# Groundwater Application Review Summary Form

Application # G- 18584

GW Reviewer M. Thoma Date Review Completed: 02-04-19

**SUBJECT: Scenic Waterway Interference Evaluation**

### Water-Level Trends in Nearby Wells

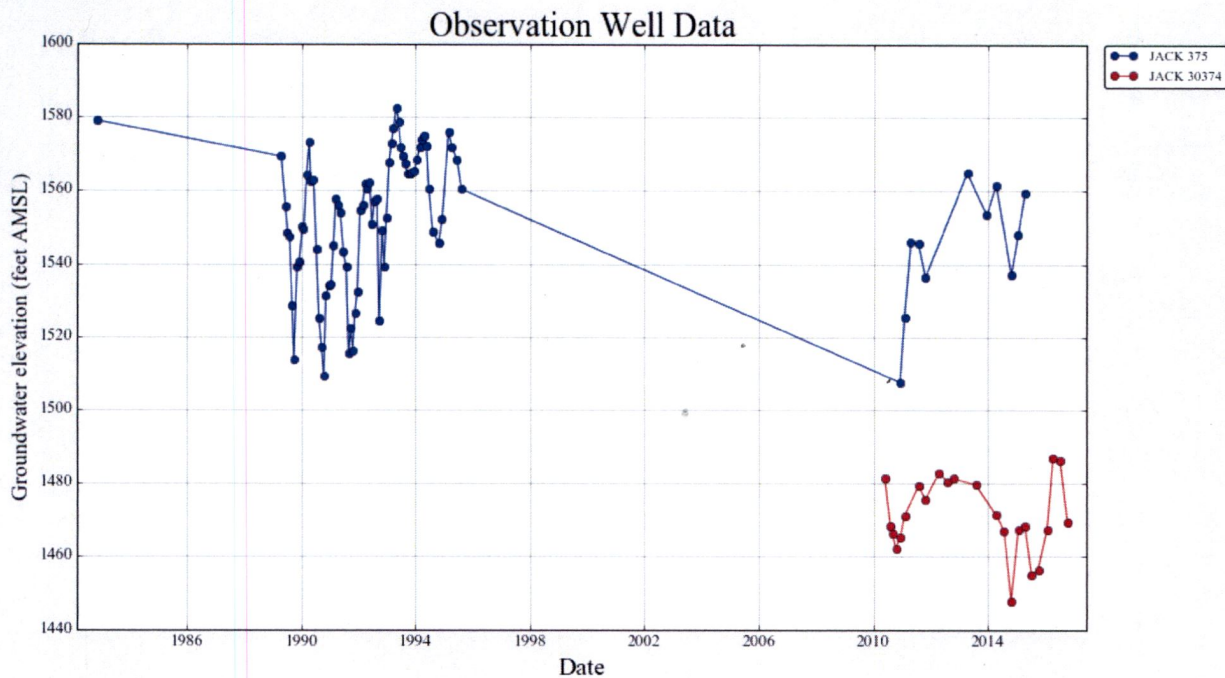
B3. **Groundwater availability remarks:** There is a non-current OWRD Obs Well within 1 mile of the proposed POA that has measurements up to 2015 (JACK 375) and a current OWRD Obs Well just over 1 mile that has current water level data but not as long a record. Data from both wells appear to track each other so a long-term record could be interpreted from the combined data set. However, it is unclear from these data whether the long-term trend is stable so Capacity of the Resource cannot be determined and the Static Water Level Condition 7N is recommended.
